Guardado Residence
BOAT HOUSE
414 Twin Timbers Ln
Kemah TEXAS 77565

FRAMING SECTION & DETAILS

S101

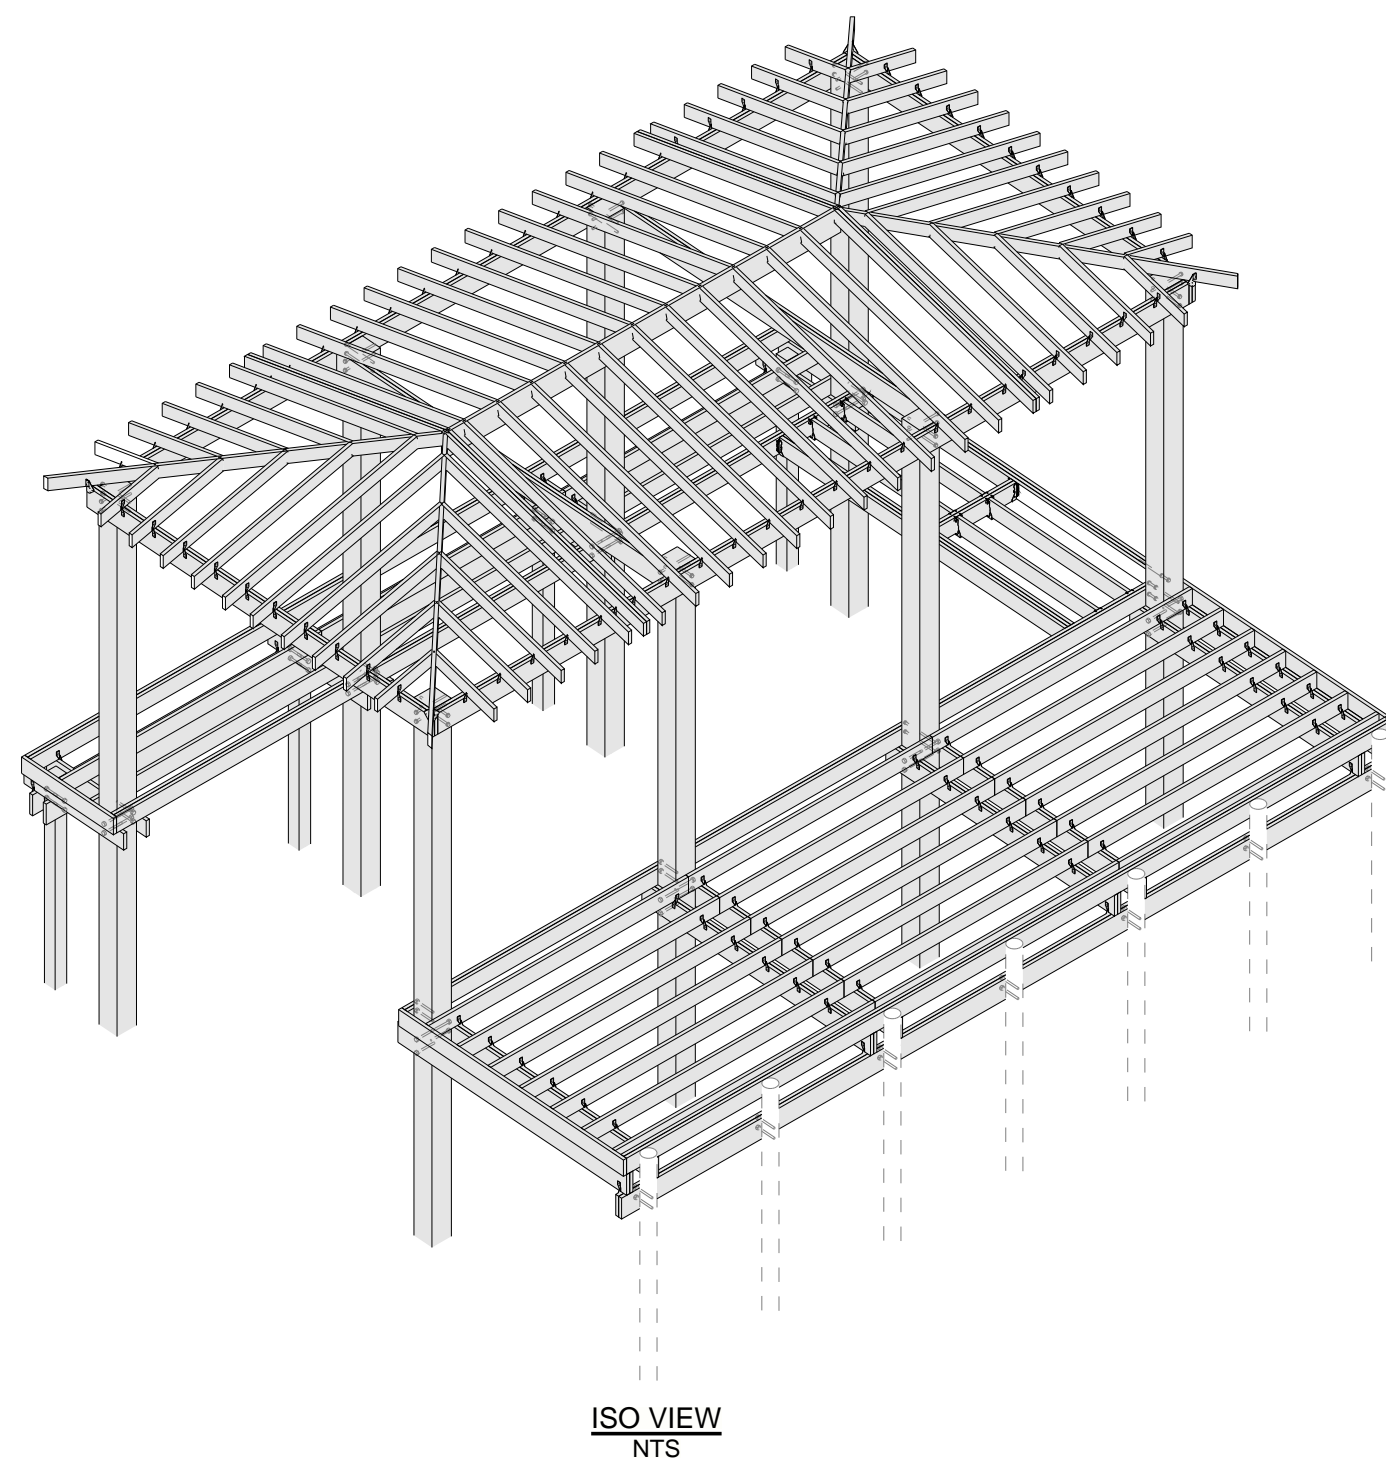
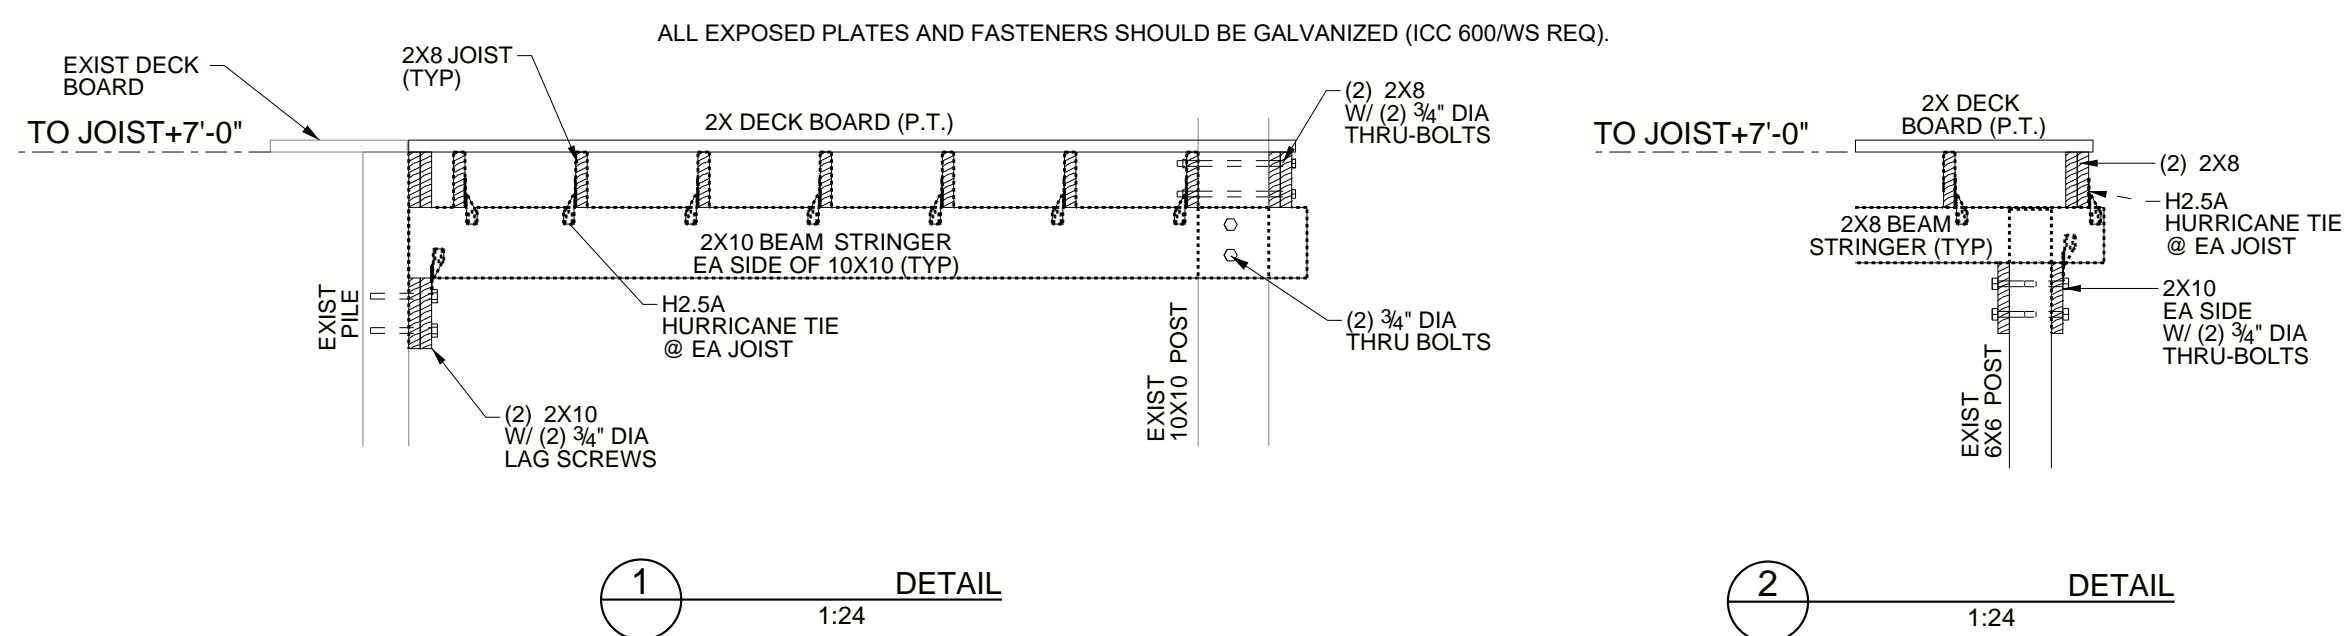
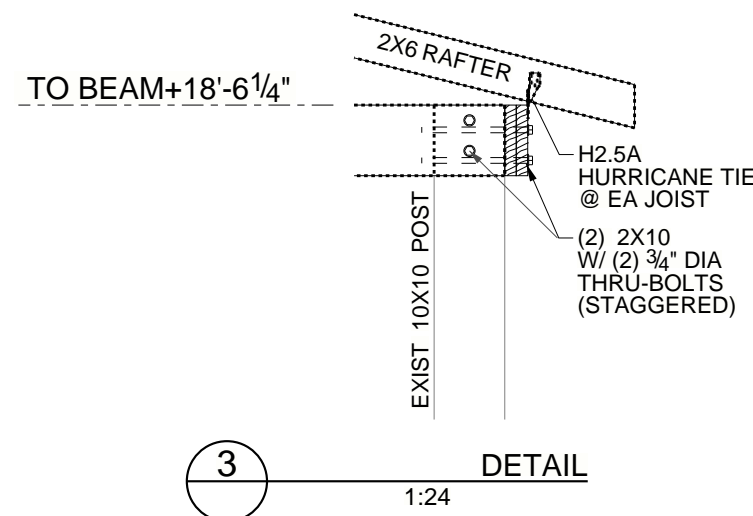
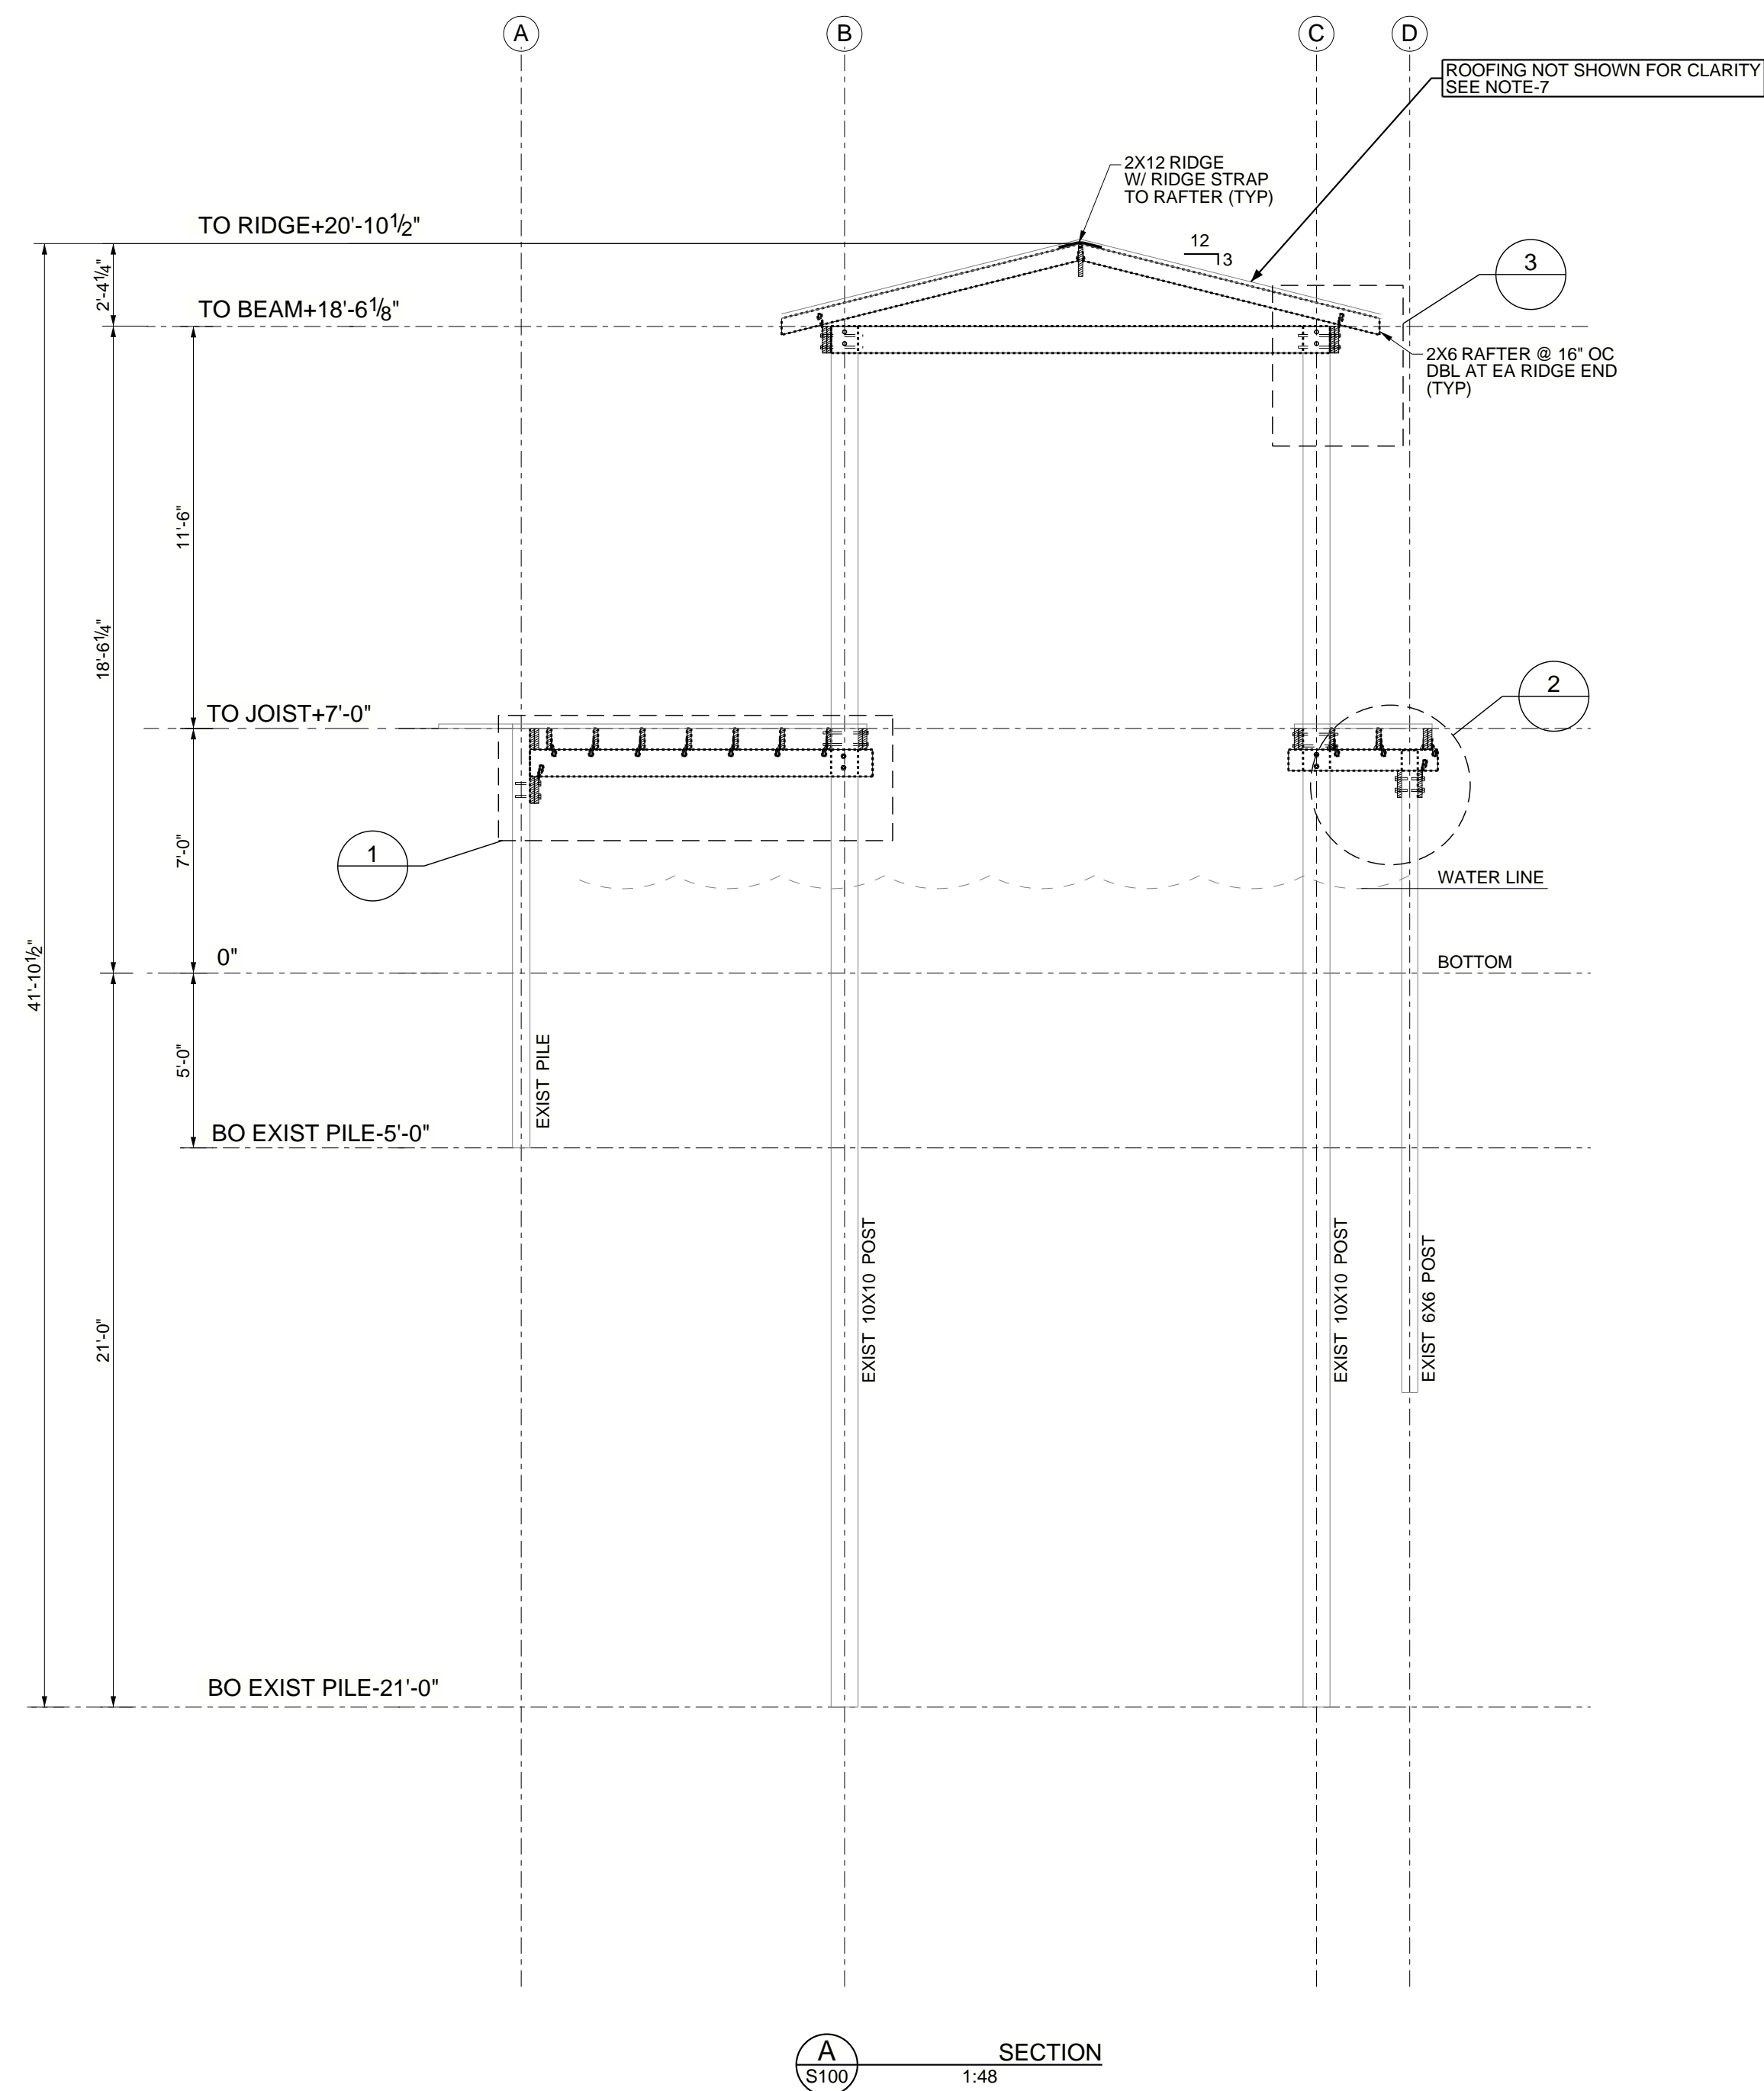
ADD CS16R HURRICANE COIL STRAP OVER HIP BEAMS CONNECTING RAFTERS.

Posts are existing. Based on information provided, post size and depth is adequate for new boat dock. Condition of existing posts are unknown. If posts are found to be in poor condition, posts need to be replaced. Engineer is not responsible for existing posts.

S102

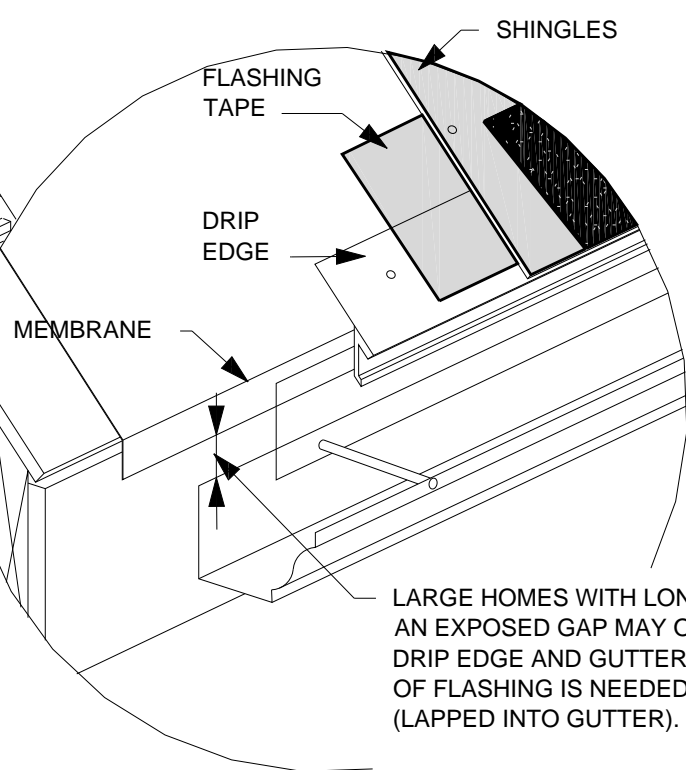
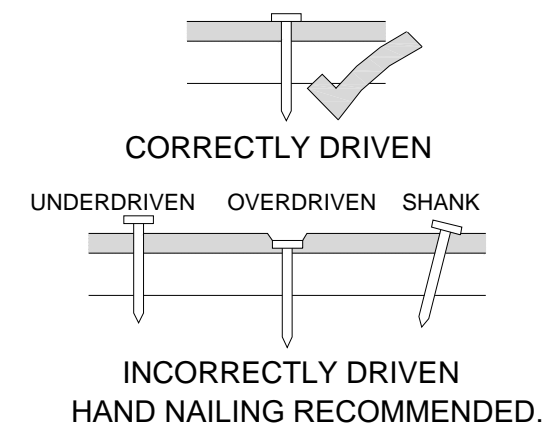
GALVANIZED ROOFING NAILS REQUIRED. FOR

QUESTIONS CONTACT ENGINEER BEFORE INSTALL.
